SERVICE BULLETIN

Herewith Revision No. 2 of Service Bulletin A320-21-1014.

SERVICE BULLETIN No.: A320-21-1014

T I T L E : AIR CONDITIONING - AIR COOLING - MODIFY FLOW CONTROL VALVES AND RELOCATE PRESSURE SENSORS

Removal of Flow Control Valves and Equipment Figure 1, Sheet 2 of 3

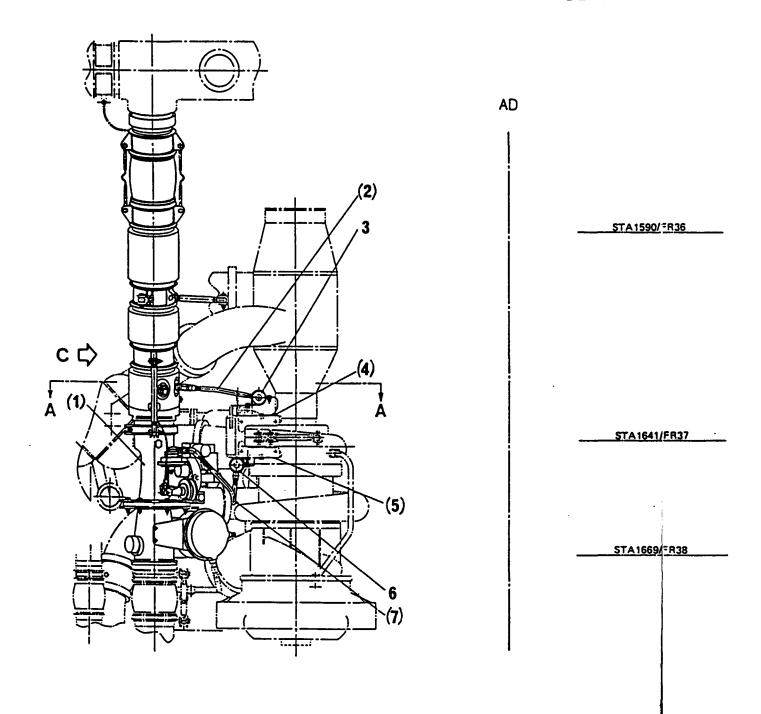
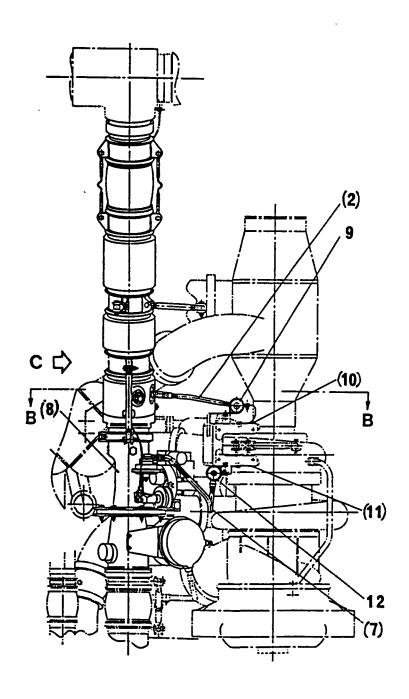
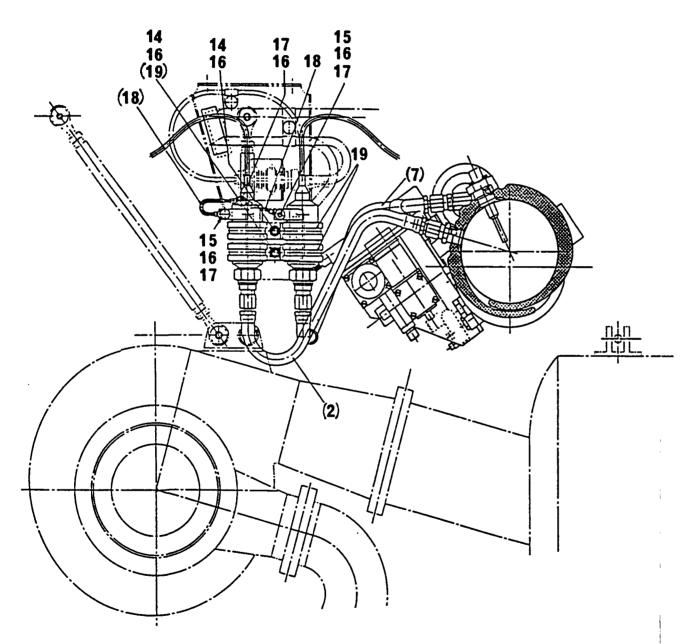
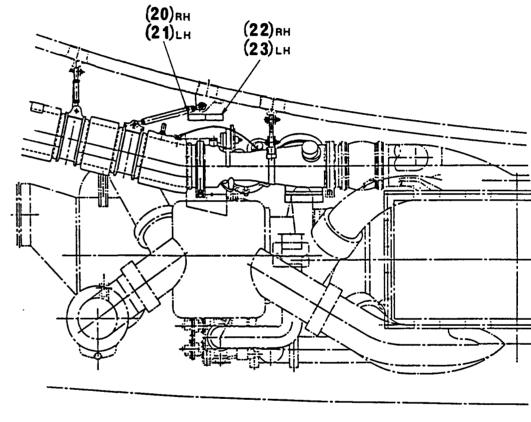
- (a) Remove the air conditioning packs 10HM (LH) and 11HM (RH) in accordance with AMM 21-52-41, P. Block 401.
- (b) Remove:

hose	item (2)	not re-used
hose	item (7)	not re-used
screw	item 14	re-used
nut	item 15	re-used
washer	item 16	re-used
screw	item 17	re-used
bonding strap	item (18)	not re-used
bonding strap	item 18	re-used
clipnut	item (19)	not re-used
clamp	item 19	re-used

- (c) Disconnect the electrical connections from the sensors and remove the clamp, item (106) and associated hardware as shown in figure 11. Do not re-use the fastening parts.
- (d) Remove and retain the sensors, item 3, 6, 9 and 12 with fastening parts.
- (e) Disconnect the hose, item (40) from the tie-rod by removing nut, item 15, washer, item 16, screw, item 30 and two clamps, item 38 and 42.
- (f) Disconnect the hose, item (40) from the flow control valve LH and RH, item (1) and (8). Do not re-use the hose.
- (g) Remove the flow control valves 8HB (LH), item (1) and 11HB (RH), item (8) in accordance with AMM 21-51-51, P. Block 401. Retain the ducts.

Removal of Pipes and Hoses Figure 2, Sheet 1 of 2

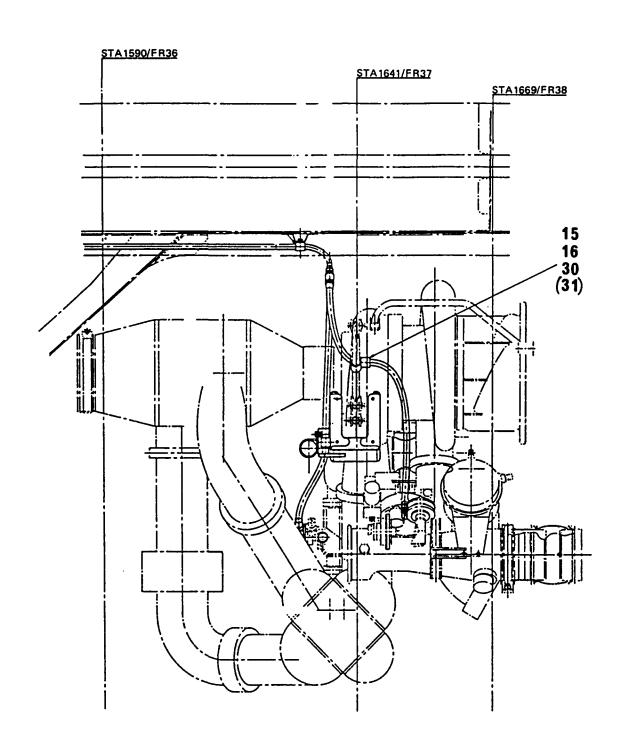
(j) Disconnect and remove:

hose	item (32), (33),	
	(34), (35)	not re-used
pipe	item (36), (37)	not re-used
nut	item 15	re-used
washer	item 16	re-used
screw	item 30	re-used
clamp	item (31)	not re-used
clamp	item (38)	not re-used

Modification of Heat Shields Figure 4, Sheet 1 of 3

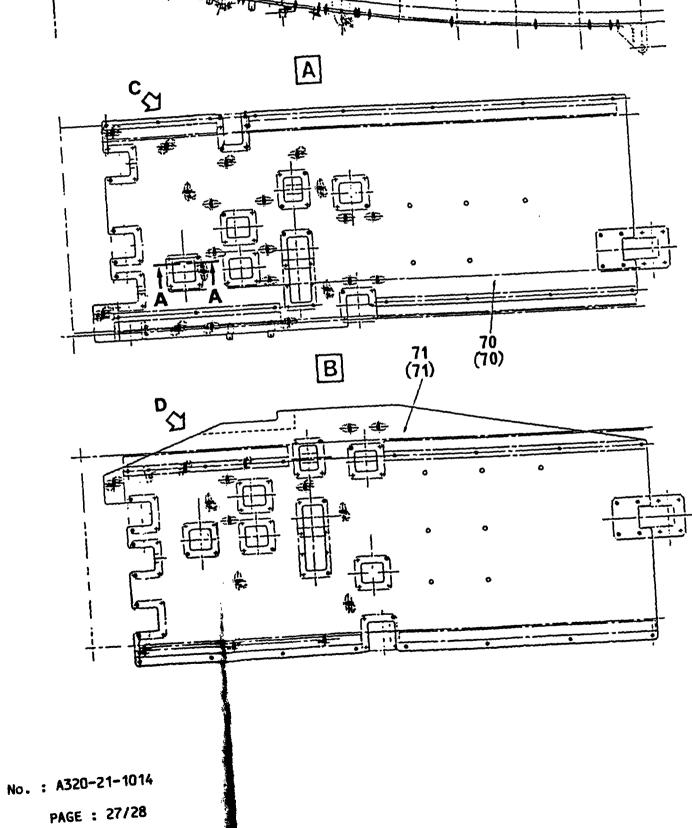
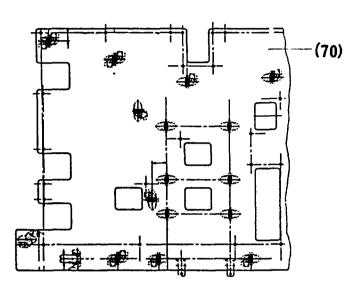
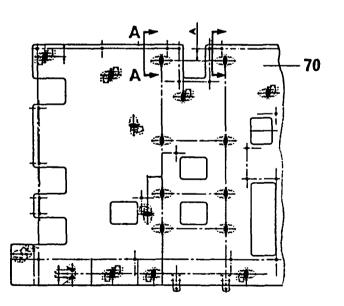
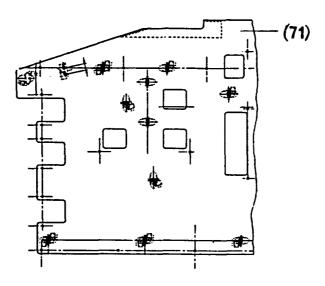
- (e) Remove the heat shields D2157137101400, item (70) and D2157137101200, item (71) from the stude and retain the fastening parts for re-use.
- (f) Place the heat shields on a bench and modify as follows:

- (f1) Mark the installation positions of the supports, item 76 on the heat shields, item (70) and (71).
 - (f2) Drill 2.4 mm (0.094 in.) rivet holes.
 - (f3) Position the supports D3627002600000, item 76 on the heat shields and install with washers ASNA53114-24ADL, item 77 and rivets MS20470AD3-6, item 78.

- (f4) Re-identify the heat shields in accordance with Para. 3.D.
- (g) At the locations given in figure 5 remove the studs, item (80), (83) and (87), washers, item (81) and lockwashers, item (72).

(j) At locations given in figure 4, section A-A install the new and retained;

- (m) Install the modified heat shields D2157137101800, item 70 and D2157137101600, item 71 with retained fastening parts.
- (n) Additionally fasten the heat shield, item 70 with new washers AN960C10L, item 16 and nuts MS21042-3, item 74 as shown in figure 4, section A-A.

Removal/Installation of Heat Shield Fasteners Figure 5, Sheet 1 of 3

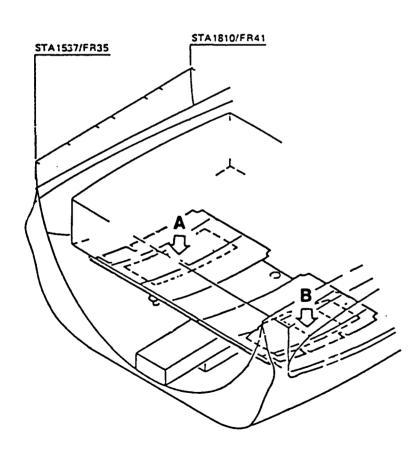
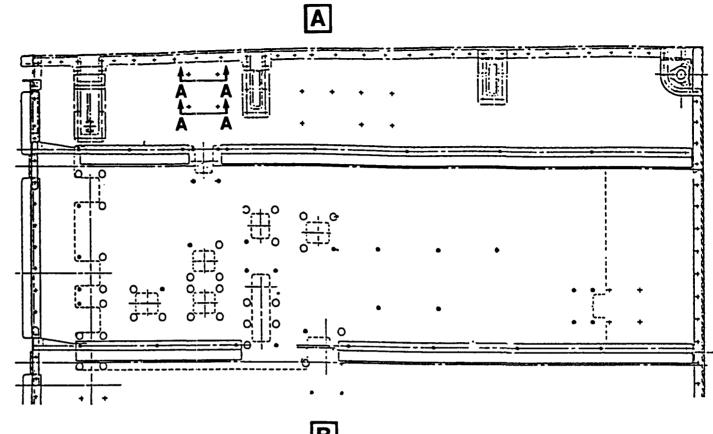
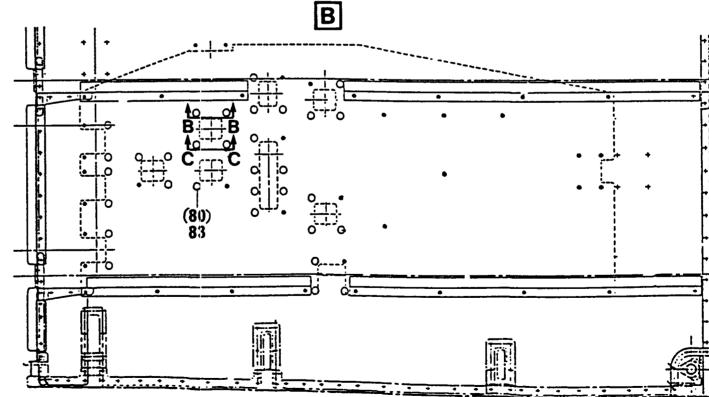
(k) At the locations given in figure 5, detail B and section B-B and C-C install the new and retained;

stud	NSA5159-25	item 84
stud	NSA5159-32	item 83
washer	AN960KD10	item 81
lockwasher	DIN137A5ST	item 72
washer	AN960C10L	item 16
screw	NAS1096-3-10	item 85

(1) At the locations given in figure 5, sheet 1 thru 3 install the new and retained;

stud	NSA5159-23	item 80
stud	NSA5159-25	item 84
stud	NSA5159-32	item 83
washer	AN960KD10	item 81
lockwasher	DIN137A5ST	item 72
washer	AN960C10L	item 16
screw	NAS1096-3-10	item 85

Installation of Support Brackets Figure 6

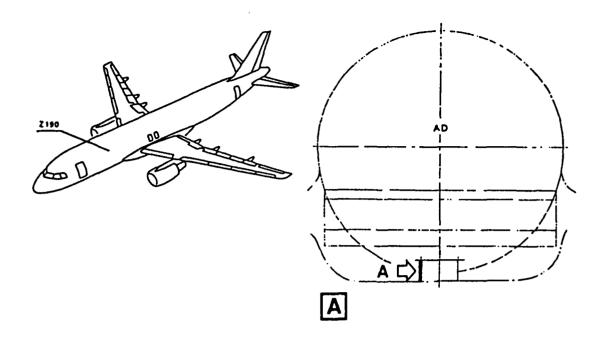
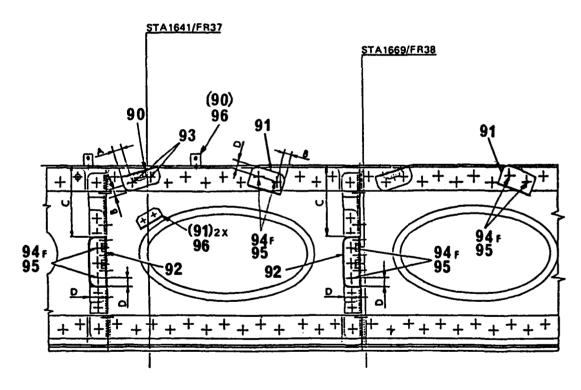
- (a) On the longeron assy, RH at FR37, put in position the sensorsupport brackets, item 60 and 61, plug-support brackets, item 62 and wire harness-support brackets, item 63 as shown in the figure.
- (b) Drill dia. 3.2 mm (0.126 in.) rivet holes for the support brackets item 63 and dia. 4.0 mm (0.157 in.) for the support brackets item 60, 61 and 62.
- (c) Install the support brackets D9249178620000, item 63 with rivets MS20470AD4-6, item 64. Use sealant Mat. No. 09-013.
- (d) Install the support brackets D2157047600000, item 60, D2157047600100, item 61 and D9249181020000, item 62 with rivets MS20470D5-6, item 65. Use sealant Mat. No. 09-013.

Structural Modification on Keel Beam Sidewall Figure 7

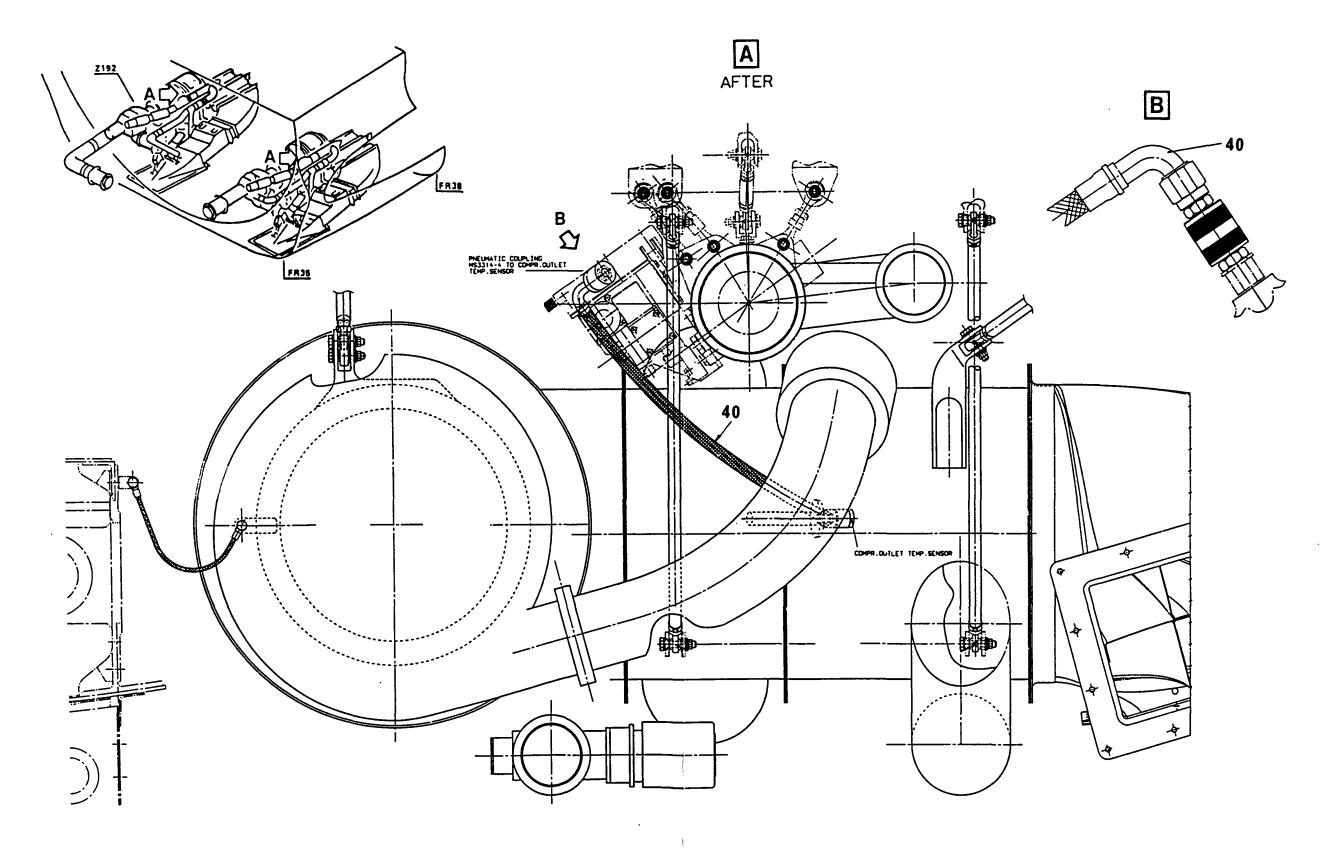
- (e) Drill out and remove the support brackets, item (91) (front and rear face) and seal the rivet holes with rivets MS20470AD4-12, item 96.
- (f) Drill out and remove the support bracket, item (90) and seal the rivet holes with rivets MS2O47OAD4-12, item 96.
- (g) Drill out rivets accordingly, where the new support brackets, item 90, 91 and 92 have to be positioned.
- (h) Put the bonding strap support bracket D5337067700200, item 90 in position as shown in the figure and drill dia. 4.8 mm (0.189 in.) rivet holes.

- (j) Install the support bracket, item 90 with rivets MS20470D6-10, item 93. Use sealant Mat. No. 09-013.
- (k) Position the support brackets D9249181120000, item 91 and D2157147720400, item 92 as shown in the figure and drill and ream dia. min. 5.113 mm (0.2013 in.) max. 5.152 mm (0.2028 in.).
- (l) Install the support brackets, item 91 and 92 with Hi-lok fasteners HL110VF-6-5, item 94 and collars HL79, item 95. Use sealant Mat. No. 09-013.
- (4) Installation of sensors

Installation of Flow Control Valve Sense Line Figure 8

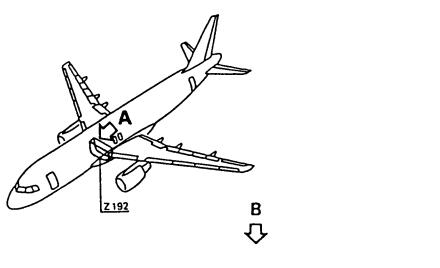
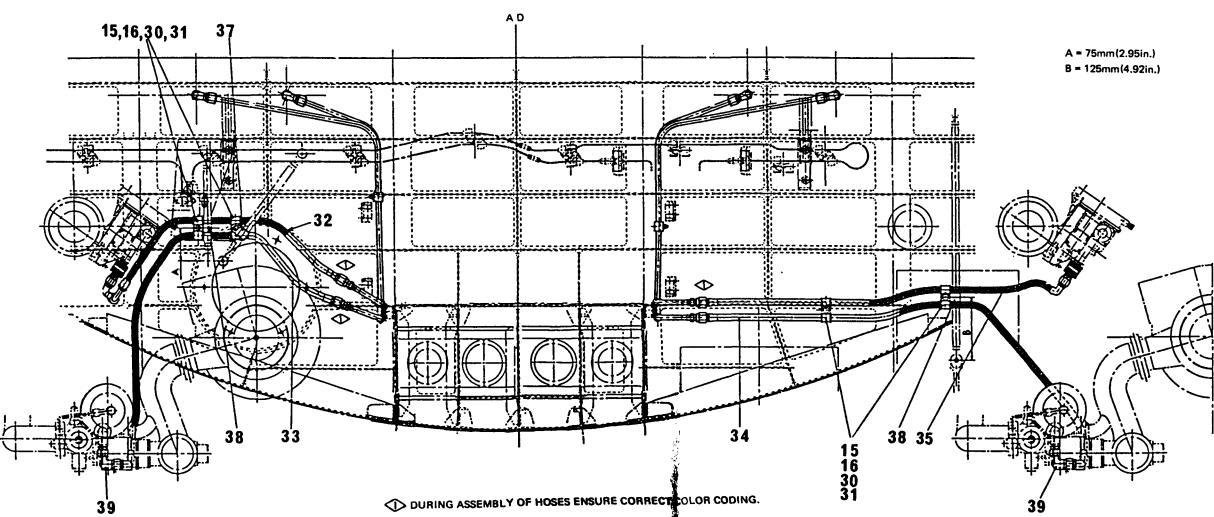
- (j) Connect the hose, item 40, LH and RH to the compressor outlet of the air conditioning pack as shown in figure 8.
- (k) Install the hoses, item 33 and 34 with elbow fittings NSA855120-6C, item 39. Secure the hoses, item 32, 33, 34 and 35 as shown in figure 9 with:

Installation of Hoses Figure 9, Sheet 1 of 2

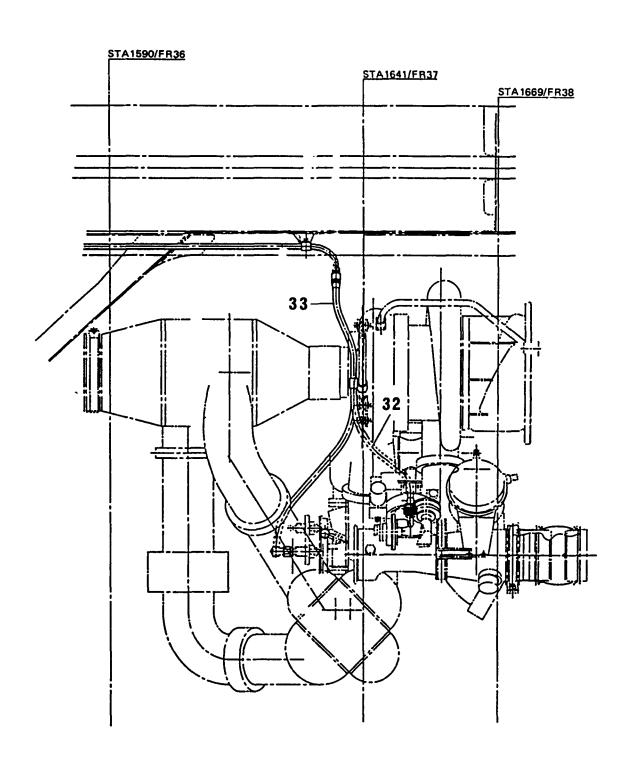
- (c) Connect the hose, item 32 to the pipe as shown in figure 9.
- (d) Connect the hose D2157143703000, item 33 to the pipe as shown in figure 9. Do not proceed with the hose installation at this stage.
- (e) On the flow control valve 11HB (RH) install as follows:

- (f) Connect the hose, item 35 to the pipe as shown in figure 9.
- (g) Connect the hose D2157143703400, item 34 to the pipe as shown in figure 9. Do not proceed with the hose installation at this stage.
- (h) Install the air conditioning packs 10HM (LH) and 11HM (RH) in accordance with AMM 21-52-41, P. Block 401.
- (i) Install the placards on the heat shields according to figure 10, Sheet 2:

clamp	NSA5516-13NJ	item 31
clamp	NSA5516-15NJ	item 37
clamp	MS21919WCJ8	item 38
screw	A104-1/2D	item 30
washer	AN960C10L	item 16
nut	MS21043-3	item 15
